**[Docket No. FAA-2010-0636; Amendment Nos. 25-140 and 33-34]**

**Airplane and Engine Certification Requirements in Supercooled Large Drop, Mixed Phase, and Ice Crystal Icing Conditions**

**ACTION:** Final rule.

FIGURE 1 — Appendix O, Freezing Drizzle, Liquid Water Content

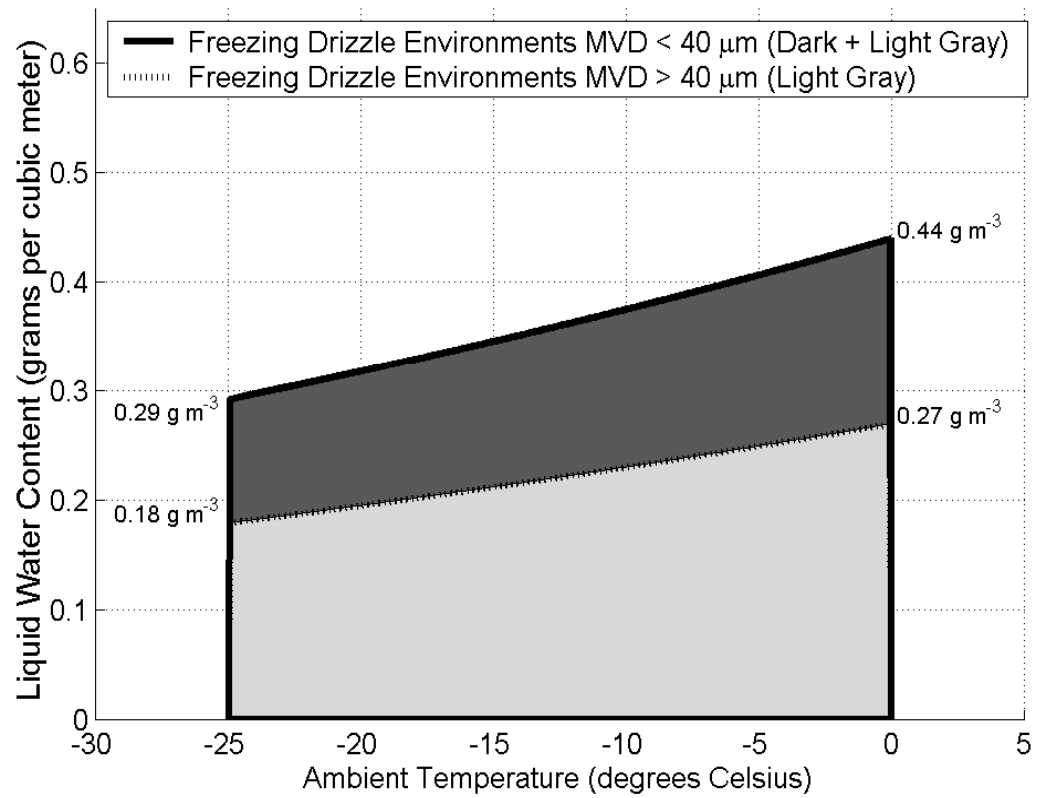
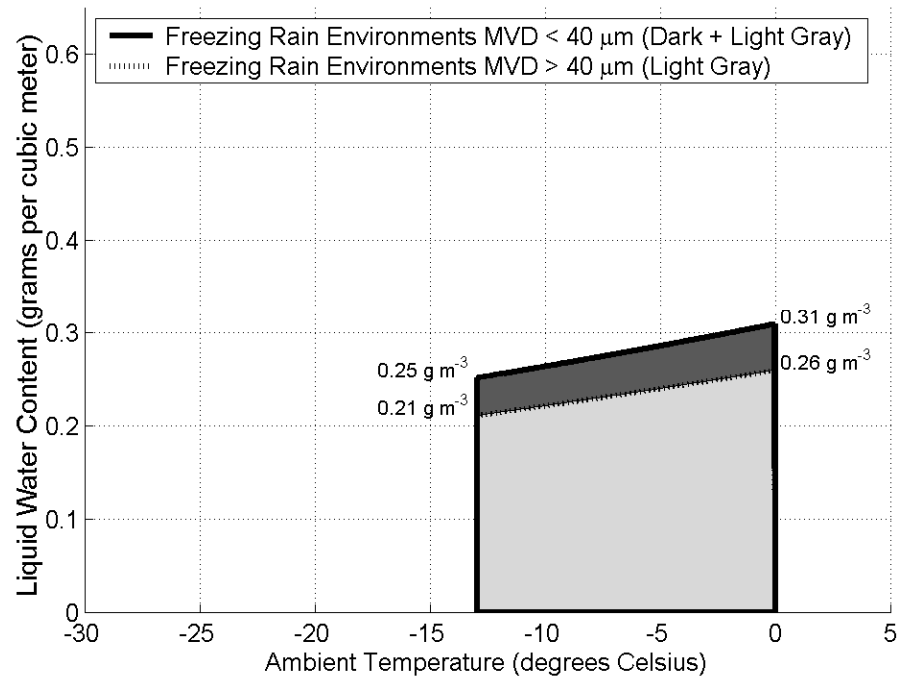
In response to other comments, figures 1 and 4 of appendix O have been revised in this final rule to reflect the LWC proposed by the IPHWG. As a result, freezing drizzle conditions with a median volume diameter (MVD) greater than 40 microns fall within the adverse region that would be identified using the University of Wyoming LWC/drop size technique. No changes to appendix O were made as a result of these comments.

Several commenters said that proposed figures 1, 4, and 7 in appendix O of the NPRM were different than what was proposed by the IPHWG, and that the FAA did not provide an explanation for those differences. The commenters also noted that the higher LWC contained in the figures proposed in the NPRM could have a significant impact on an applicant's design. GSIS specifically noted that the higher water content defined in appendix O will have the effect of greatly increasing power requirements for electro-thermal deicing systems. Several commenters also suggested that figures 1, 3, 4, and 6 of appendix O would be easier to use if the corner data points were defined in the figures.

We agree. We reviewed the figures proposed in the NPRM and the data used by the IPHWG to generate the figures. We revised figures 1 and 4 to reflect the lower water content values proposed by the IPHWG, but the water content in appendix O is still higher than within appendix C at the same temperature. The higher water content may increase the power requirements for some electro-thermal deicing system designs, but not to the extent that may have been necessary with the water contents proposed in the NPRM. The environmental conditions defined in appendix O are valid conditions that will need to be considered for applicable future designs. Our review of the data used to generate the scaling factor curve in figure 7 indicates that the figure 7 proposed by the

Figures 1, 3, 4, and 6 of appendix O in this final rule have been revised to identify the corner data points for clarity.

FIGURE 6 — Appendix O, Freezing Rain, Temperature and Altitude

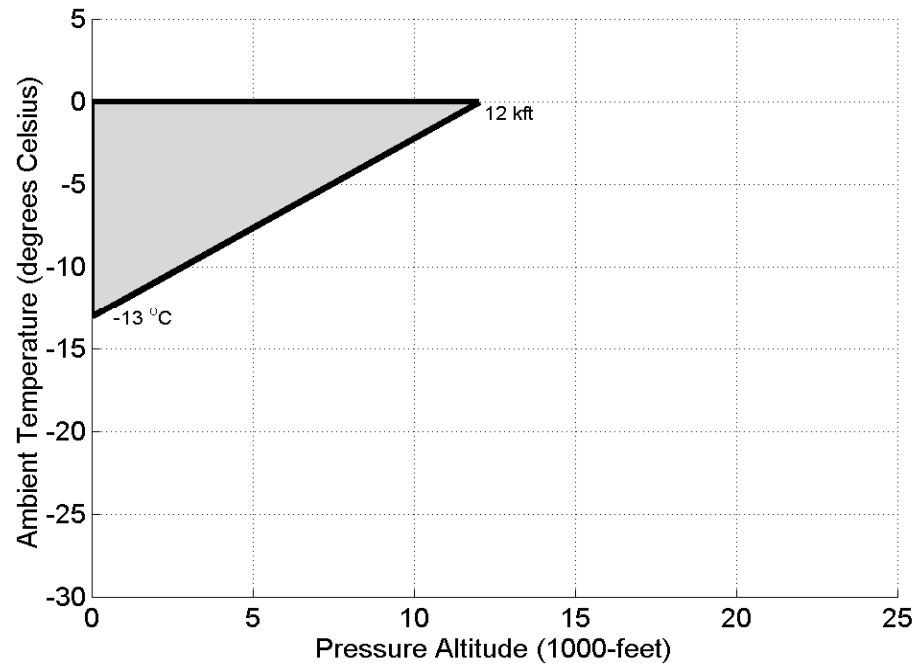
One commenter, a private citizen, noted that the NPRM did not identify the vertical extent for part 25, appendix O, figure 6. We disagree. The pressure altitude range and vertical extent for freezing rain were provided in appendix O, part I, paragraph (b) in the NPRM located under figure 3. We clarified appendix O, part I, by moving all of the general text describing the meteorological parameters, including vertical extent, ahead of the figures.

FIGURE D3 — Exposure Length Influence on TWC

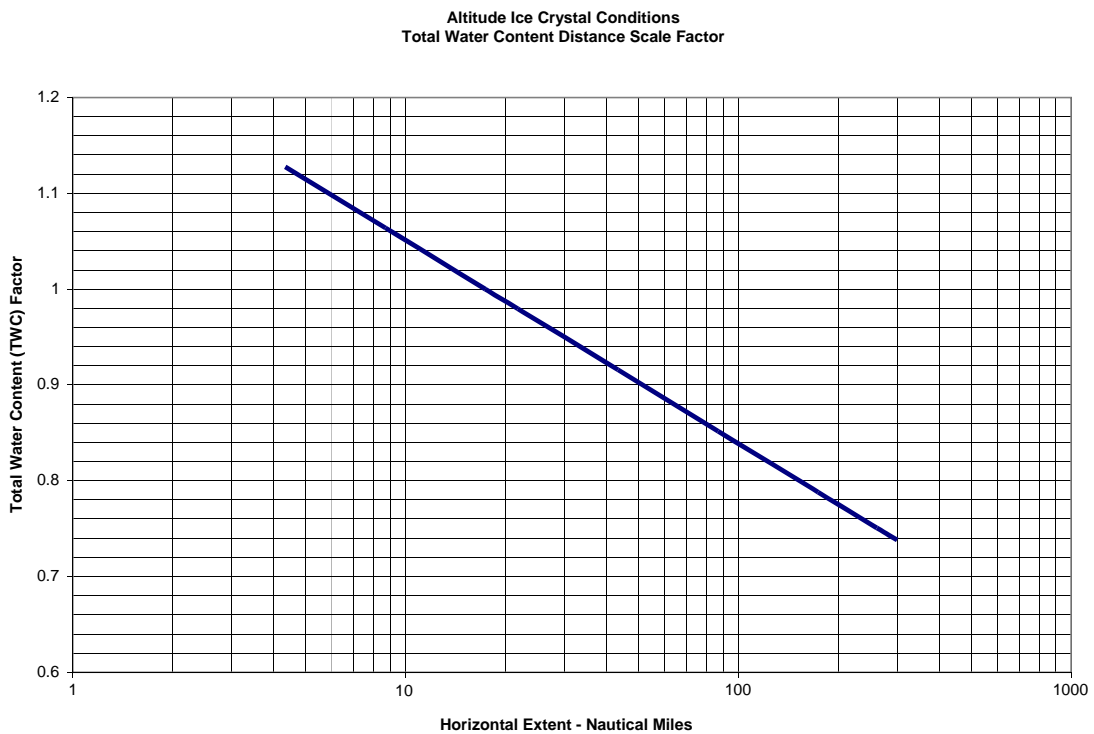
Snecma commented that the y-axis value in proposed part 33, appendix D, figure D3, was incorrect. The value should be 0.6 but the NPRM showed the value as zero.

We concur. We also found that both the x- and y-axis values proposed in the NPRM were incorrect. We changed part 33, appendix D, figure D3, to depict the correct axis values. The lowest x-axis value is now 1 and the lowest y-axis value is now 0.6.
